DRB Review

71st Street and Indian Creek Drive

Town Center Gateway

INDIAN CREEK DRIVE & 71st STREET - CLASS A STREETS

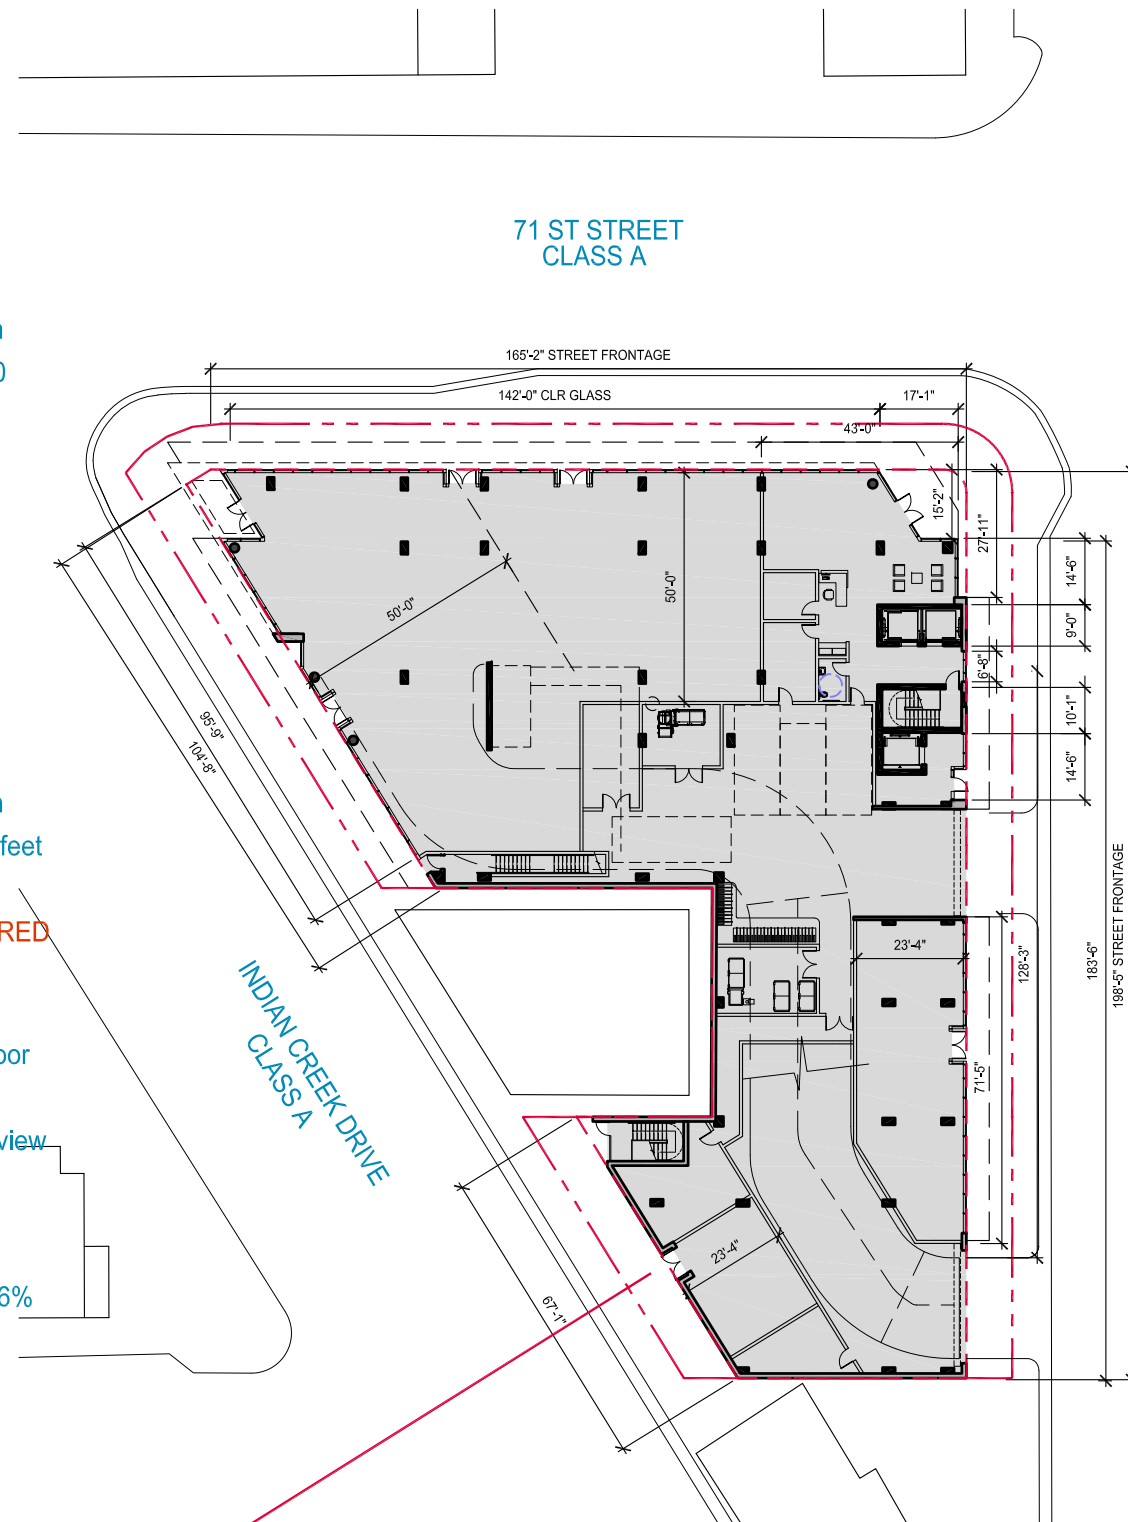
SEC 142-745 d.g.1 Facades shall have a minimum height of 35'
Proposed height 55' tall

SEC 142-745 d.e.2: Buildings shall have a minimum of three floors located along a minimum of 90 percent of the setback line.

71 st Street
90% x 165'-2" = 148'-7"
Provided 143'-11" = 87%
VARIANCE 7 REQUIRED

Indian Creek Drive
90% x 171'-9" = 154'-6"
Provided = 156'-11" = 91%

SEC 142-745 d.e.2.b: The ground floor shall contain habitable space with a minimum depth of 50 feet from the building facade
95'-9" / 171'-9" = 56%- **VARIANCE 4 REQUIRED**

SEC 142-745 a.8.d: No more than 35 percent of the required habitable space along the ground floor of a building frontage shall be for access to upper levels, unless waived by the design review board
71 st Street
total habitable frontage = 142'
frontage for access to upper floors=43'-0"=26%

Indian Creek Drive
total habitable frontage = 95'-9"
frontage for access to upper floors=0=0%

SEC 142-745 e.6:
VARIANCE 6 REQUIRED
To allow FPL / mechanical rooms on Class A street

**INDIAN CREEK DRIVE &
71st STREET -CLASS A STREETS**

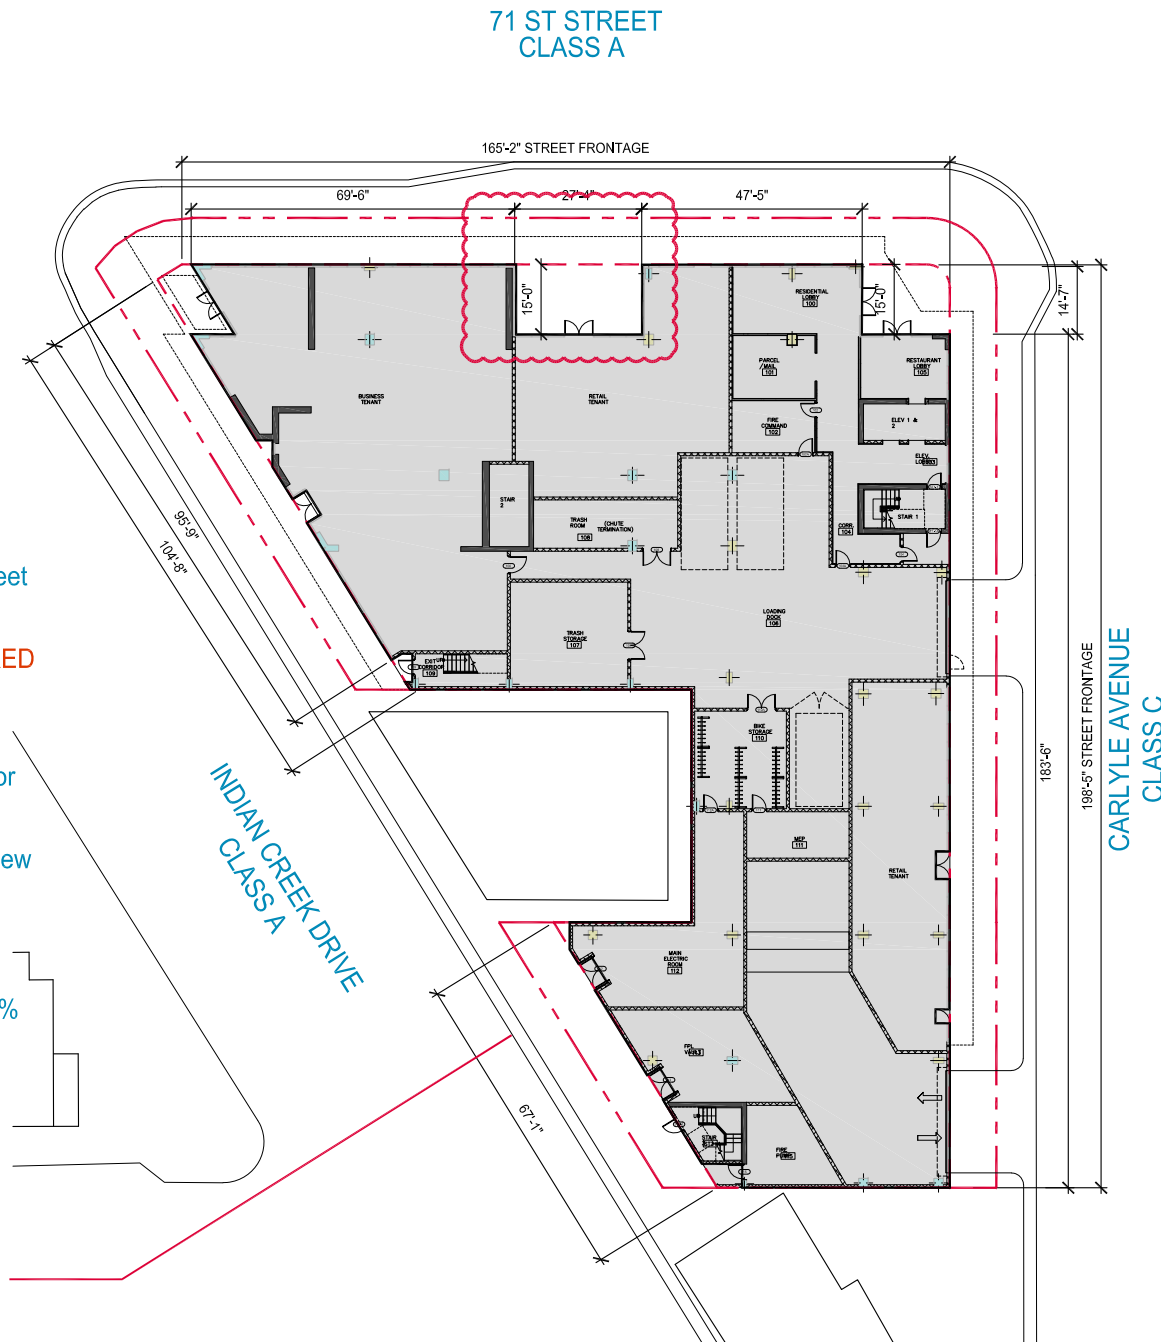
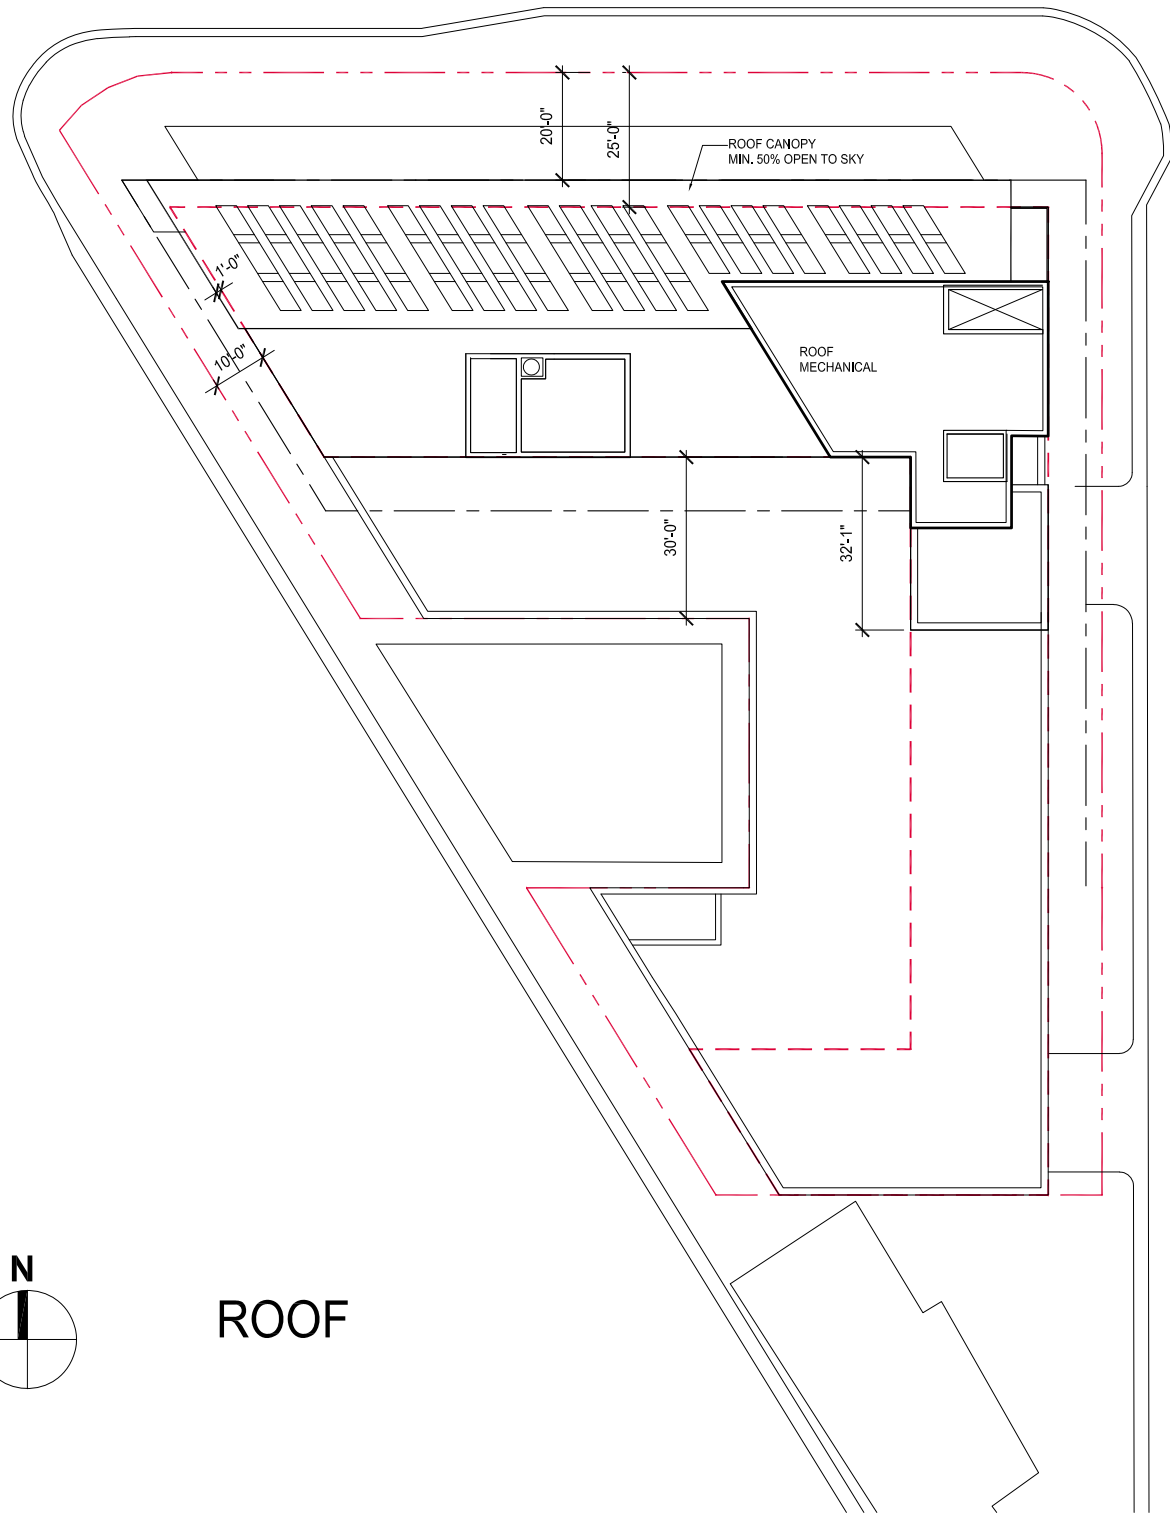
SEC 142-745 d.g.1 Facades shall have a minimum height of 35'
Proposed height 55' tall

SEC 142-745 d.e.2: Buildings shall have a minimum of three floors located along a minimum of 90 percent of the setback line.

71 st Street
 $90\% \times 165'-2" = 148'-7"$
Provided 116'-11"
VARIANCE 7 REQUIRED

Indian Creek Drive
 $90\% \times 171'-9" = 154'-6"$
Provided = 156'-11" = 91%

SEC 142-745 d.e.2.b: The ground floor shall contain habitable space with a minimum depth of 50 feet from the building facade
 $95'-9" / 171'-9" = 56\%$ - **VARIANCE 4 REQUIRED**

SEC 142-745 a.8.d: No more than 35 percent of the required habitable space along the ground floor of a building frontage shall be for access to upper levels, unless waived by the design review board

71 st Street
total habitable frontage = 142'
frontage for access to upper floors=43'-0"=26%

Indian Creek Drive
total habitable frontage = 95'-9"
frontage for access to upper floors=0=0%

SEC 142-745 e.6:
VARIANCE 6 REQUIRED
To allow FPL / mechanical rooms on Class A street

SEC 142-745 d.g.1 Facades shall have a minimum height of 35'
Proposed height 37'-6" tall

SEC 142-745 d.g.2: Buildings shall have a minimum of one floor located along a minimum of 85 percent of the setback line.

$85\% \times 198'-5" = 168'-7"$
 $183'-6" = 92\%$

SEC 130-101: Required loading
Based on 110 units a total of 4 loading spaces required.

VARIANCE REQUIRED
to provide 3 spaces in lieu of 4 due to ground floor geometrical constraints.

SEC 142-745 d.g.2.c: Except where required for driveways and utility infrastructure, the ground floor shall contain habitable space for residential, hotel, or commercial uses with a minimum depth of 20 feet from the building facade for the minimum required length along the setback line
PROVIDED

SEC 142-745 a.8.d: No more than 35 percent of the required habitable space along the ground floor of a building frontage shall be for access to upper levels, unless waived by the design review board
Total habitable frontage = 80'
frontage for access to upper floors = 28' = 35%

13TH FLOOR

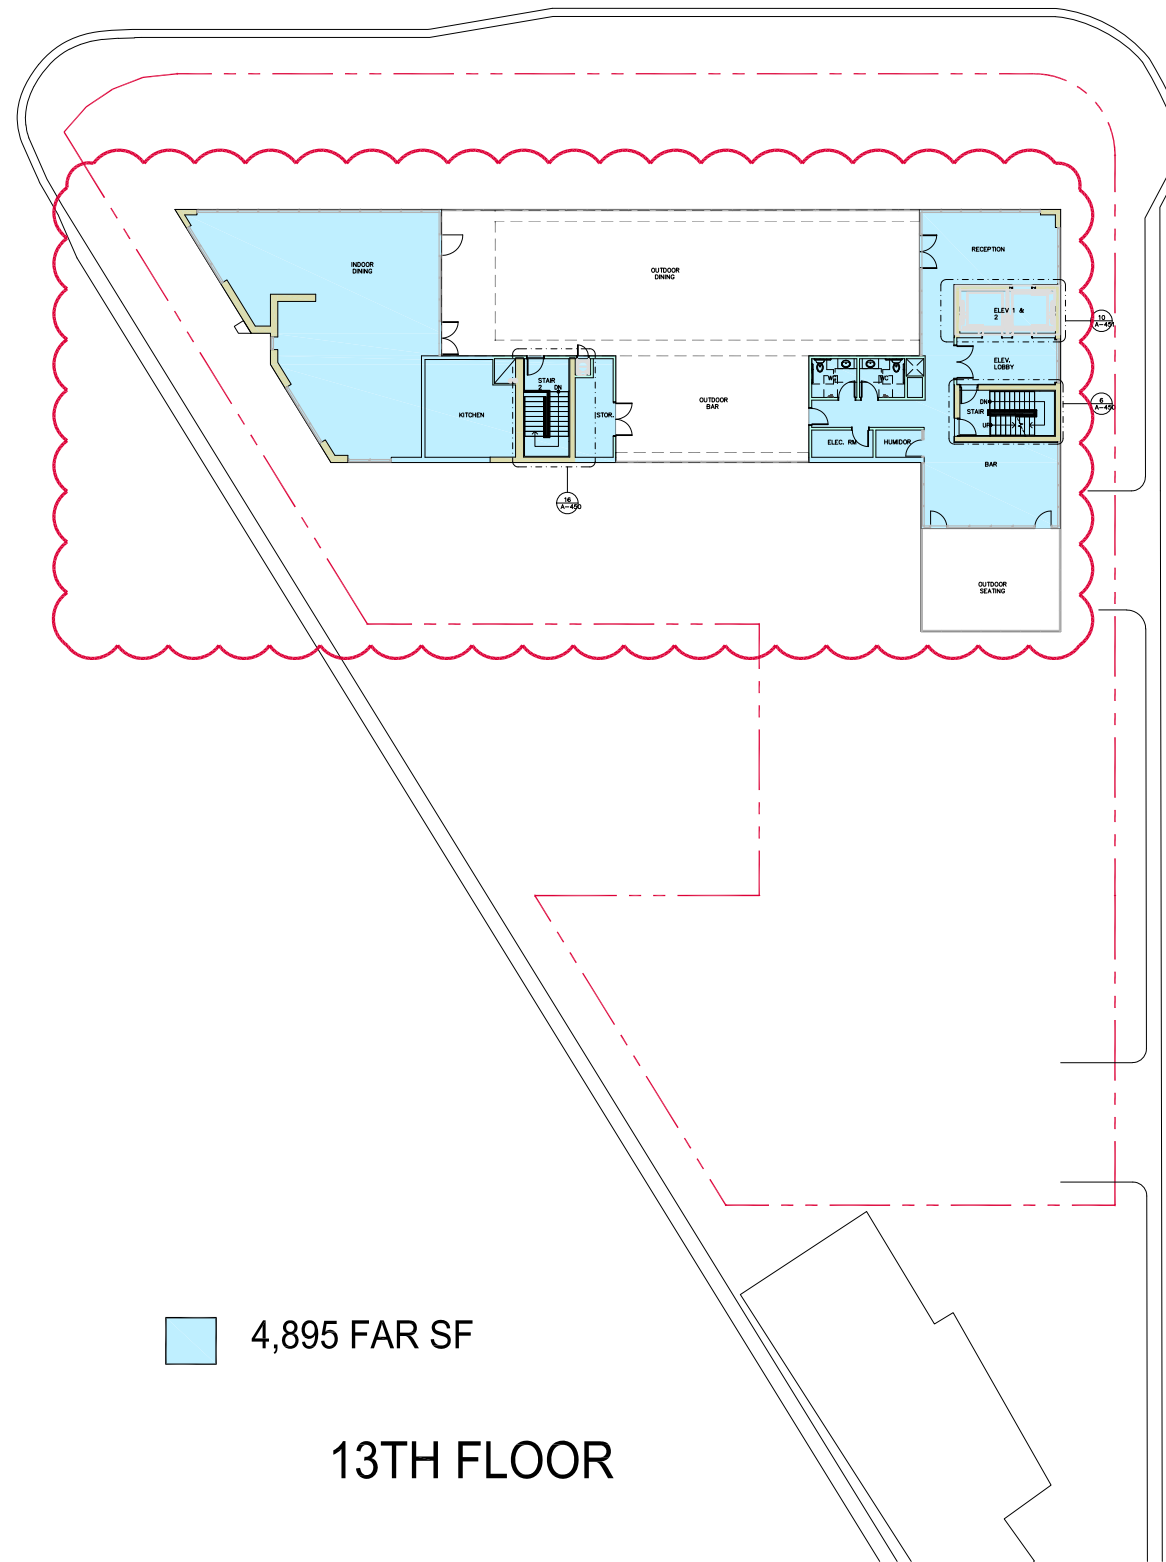
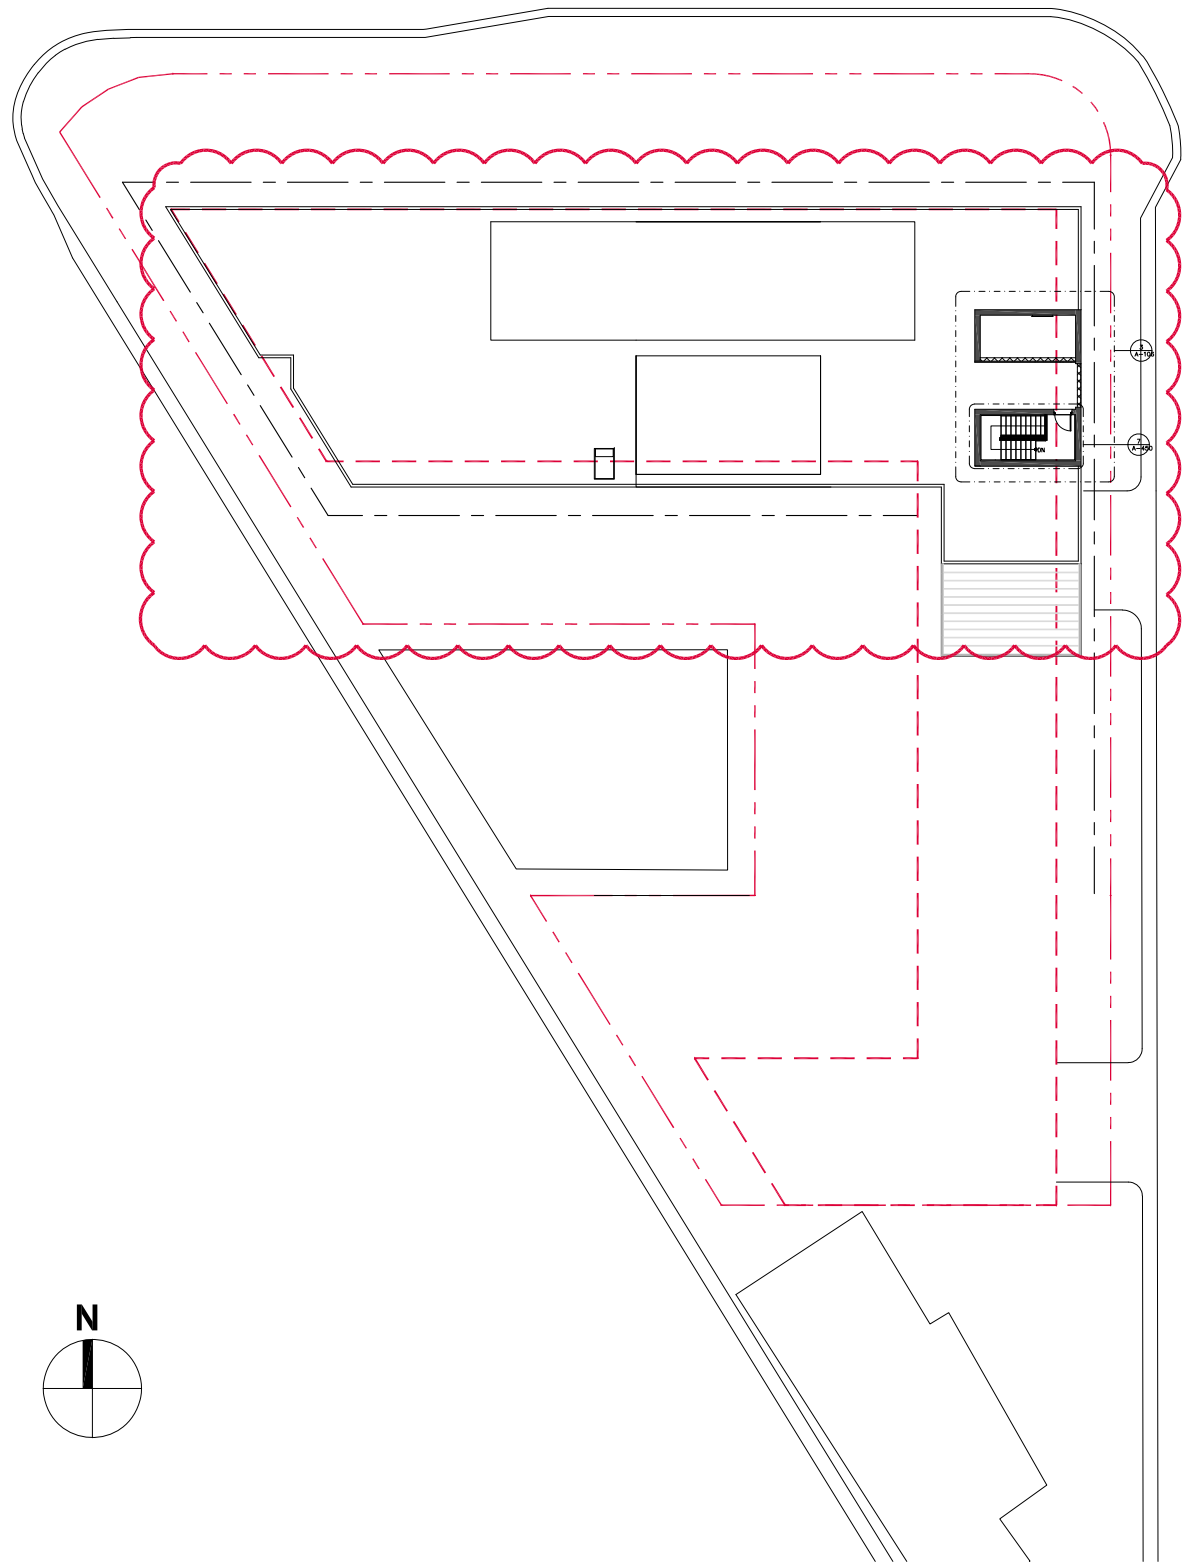
PROPOSED CHANGES

- 1- EXTENDED ROOF VOLUME UP
- 2- LOWERED PODIUM BY 1 FLOOR
- 3- COMBINED NORTH BALCONIES
- 4- ADDED STUCCO AT SHEAR WALL

PROPOSED CHANGES

- 1- BREAKING CORE MASS
- 2- BRINGING WINDOW WALL FLUSH TO SLAB
- 3- COMBINED NORTH BALCONIES

BASED ON STAFF INPUT :

- 1. ADDED BACK SPANDREL GLASS AT SHEAR WALL
- 2. BROKE DOWN THE NORTH BALCONY RUN
- 3. LOWER SOUTH WEST ROOF LINE

BASED ON STAFF INPUT

- 1- RECONNECT CORE MASS
- 2- RECESSED WINDOW WALL AT CORE
- 3- BROKE DOWN NORTH BALCONIES

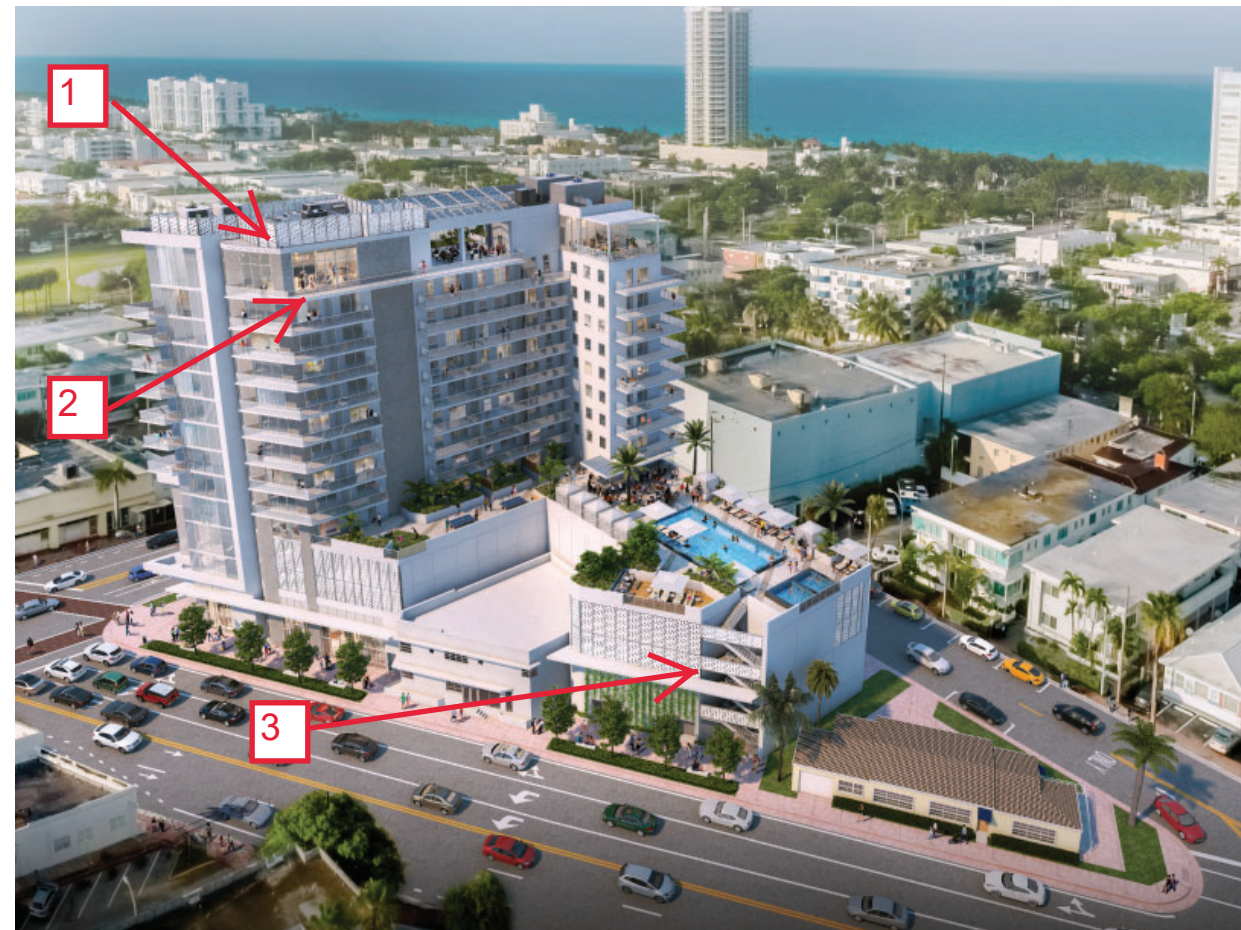
PROPOSED CHANGES

- 1- RAISED ROOF MASSING LEVEL TO FIN
- 2- SOLID STUCCO WALL- MINIMAL GLAZING
- 2- NO OPENINGS IN SCREENS AT STAIR

BASED ON STAFF INPUT

- 1- DROPPED ROOF LINE TO MAINTAIN FIN HIERCHY
- 2- ADDED BALCONY LINE TO MAINTAIN THE FACADE ARTICULATION IN ORIGINAL DRB
- 3- ADDED OPENINGS IN STAIR SCREEN
